# CITY OF PORTLAND, MAINE

## HISTORIC PRESERVATION BOARD

#### HISTORIC PRESERVATION BOARD MEETING

**TO:** Chair Pollard and Members of the Historic Preservation Board  
**FROM:** Rob Wiener, Preservation Compliance Coordinator  
**DATE:** October 2, 2020  
**RE:** October 7, 2020 **Public Hearing** – Exterior Alterations, Wharf Street Level

2 | PROPOSED CENTER ST. FACADE  
1/4" = 1'-0"

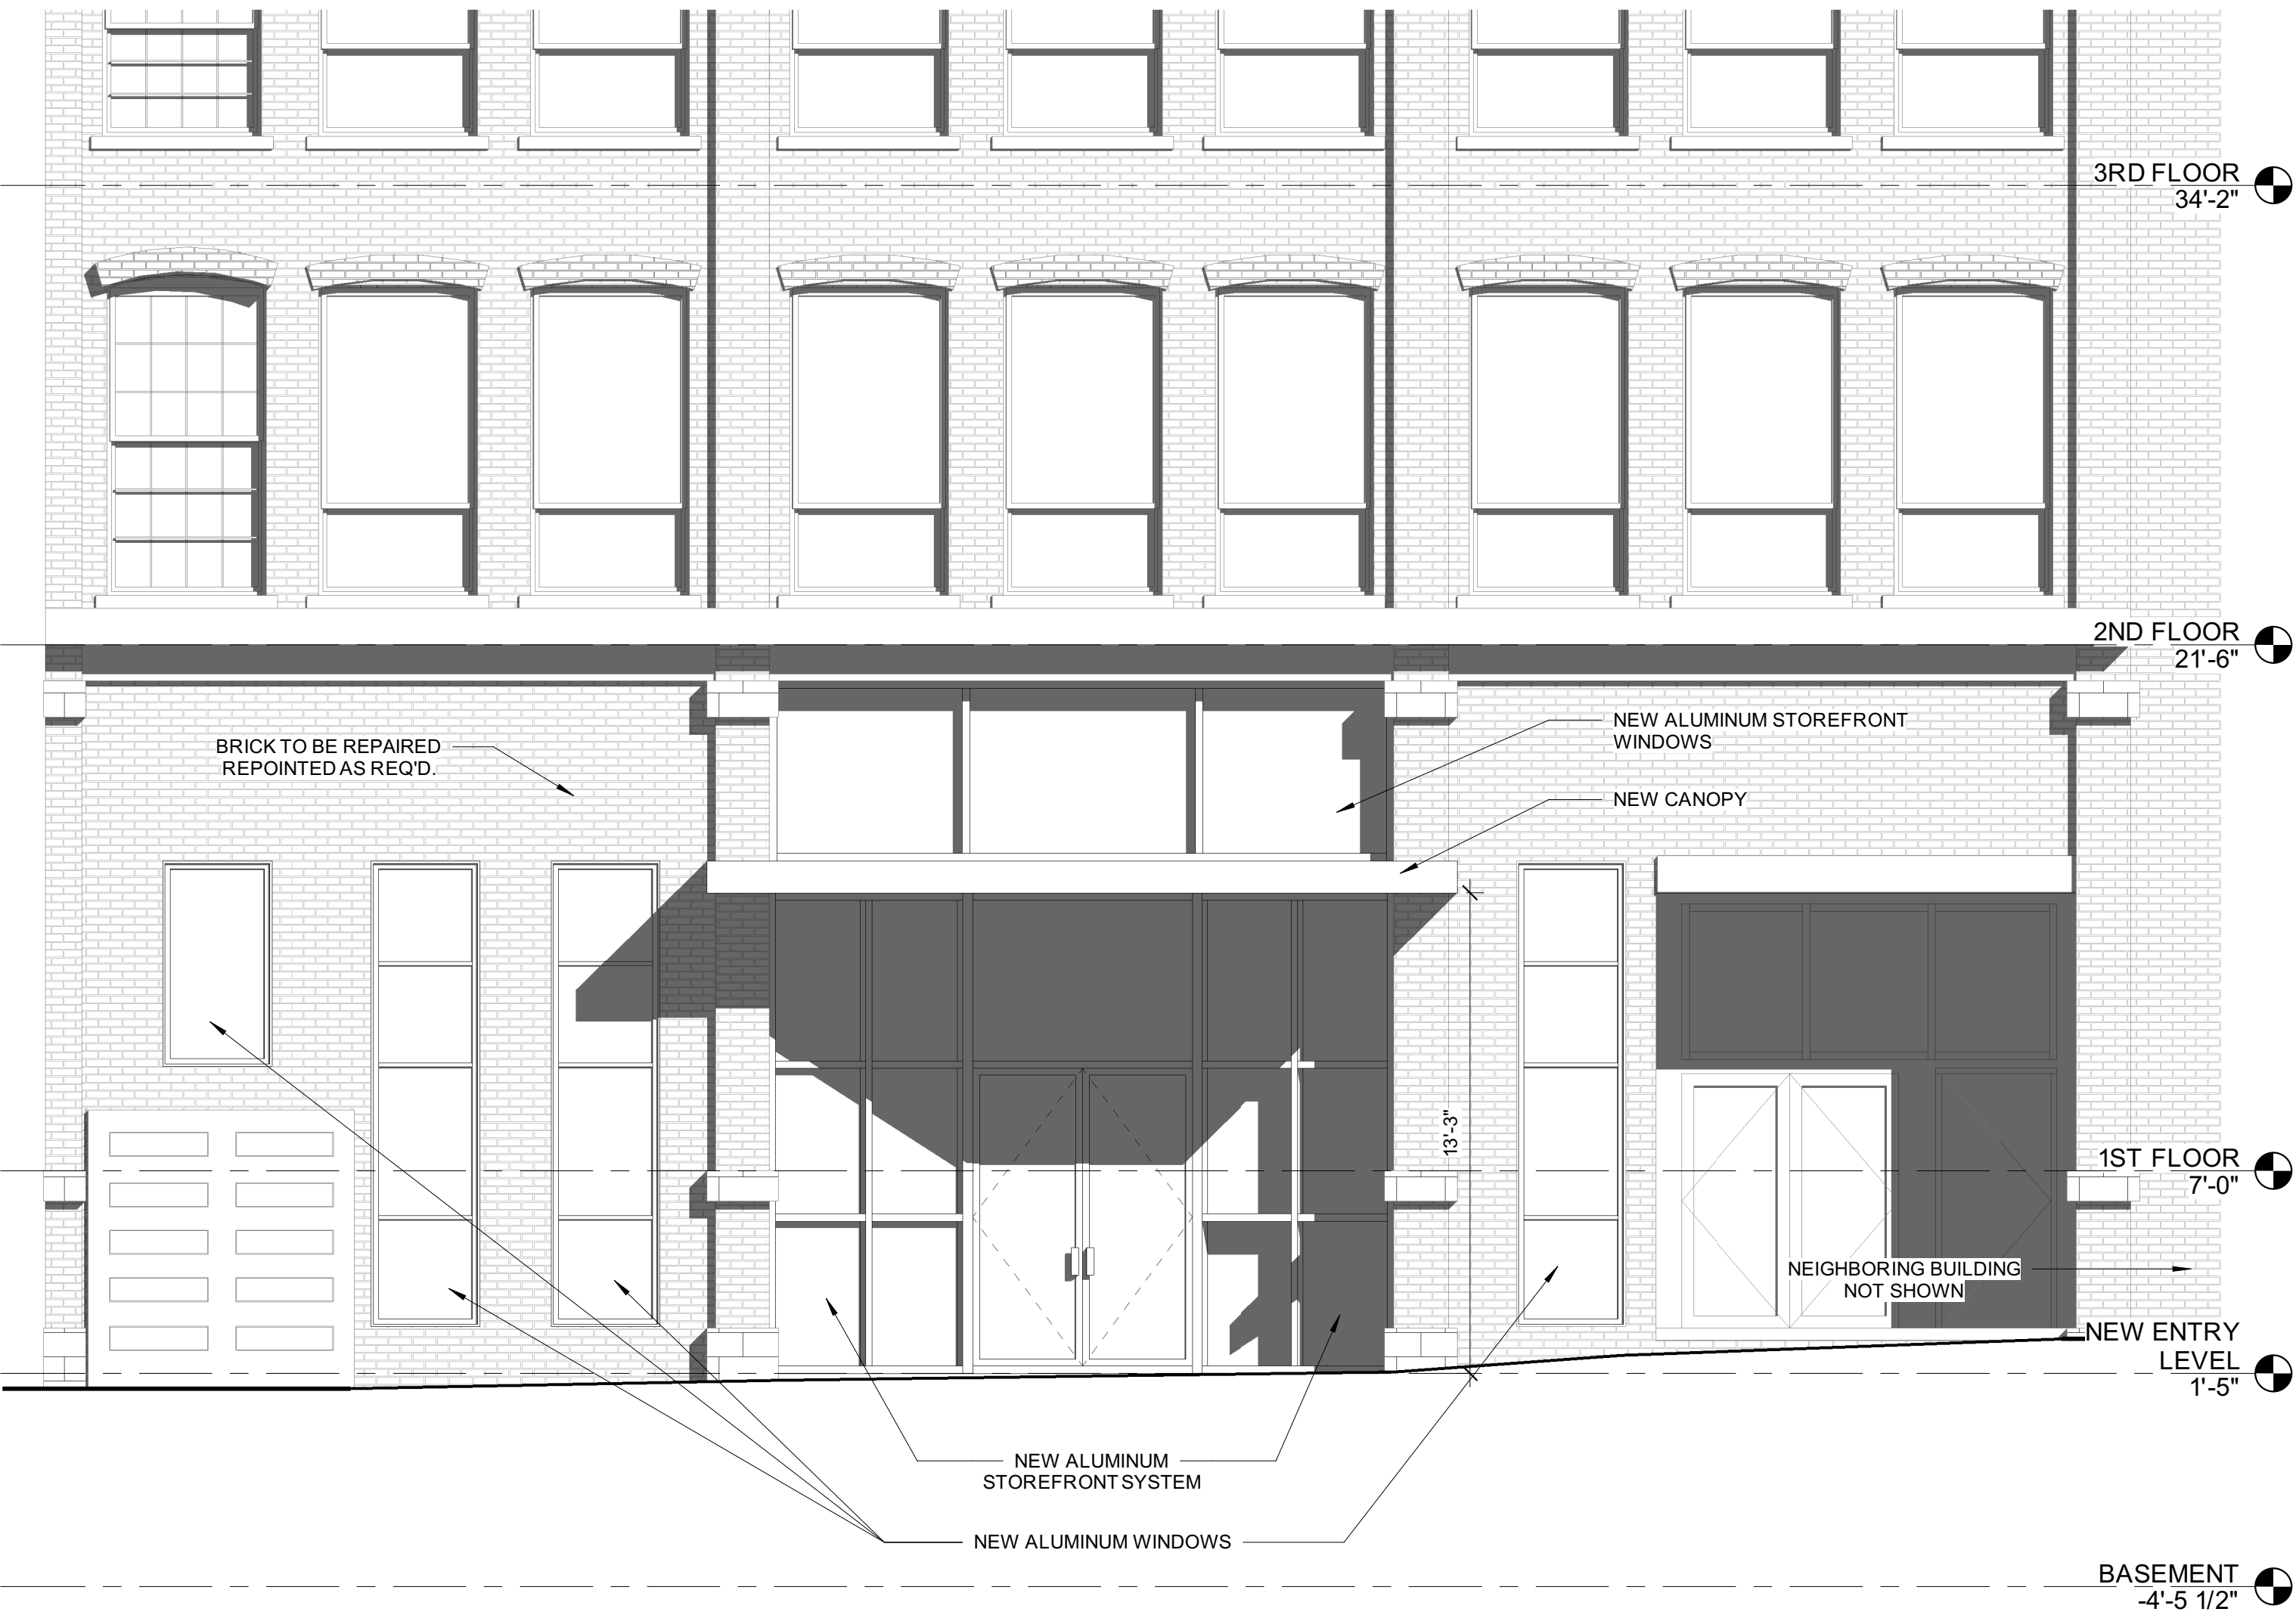
- Design details for the canopy have not been provided, but see description above. The Board will want to determine whether they want to see the details or leave final review to staff. There may be signage atop the canopy, according to the architect.
- The color of the existing upper storefront entry is bronze, as are upper floor windows. Proposed storefront components and windows are described by Mr. Broadbent as being dark – black or dark grey, to align with existing windows.
- Staff is unfamiliar with the age of the upper entrance. Is any work planned there in

- the next several years? Mr. Broadbent has asked the owners, but has not heard.
- What surface is proposed for the threshold at the recessed entrance alcove?
  - Some engineering is often required with a sloping sidewalk, and a new or renovated entrance. Staff hopes that concerns for ADA compliance, including sidewalk leveling or adjustment of the cross slope will not seriously impact the design.
  - There is an existing Fire Department Connection in the brick infill to be removed. Staff hopes a suitable substitute location has been found.
  - In response to staff's question Mr. Broadbent said exterior lighting is going to be recessed in the proposed canopy ceiling.
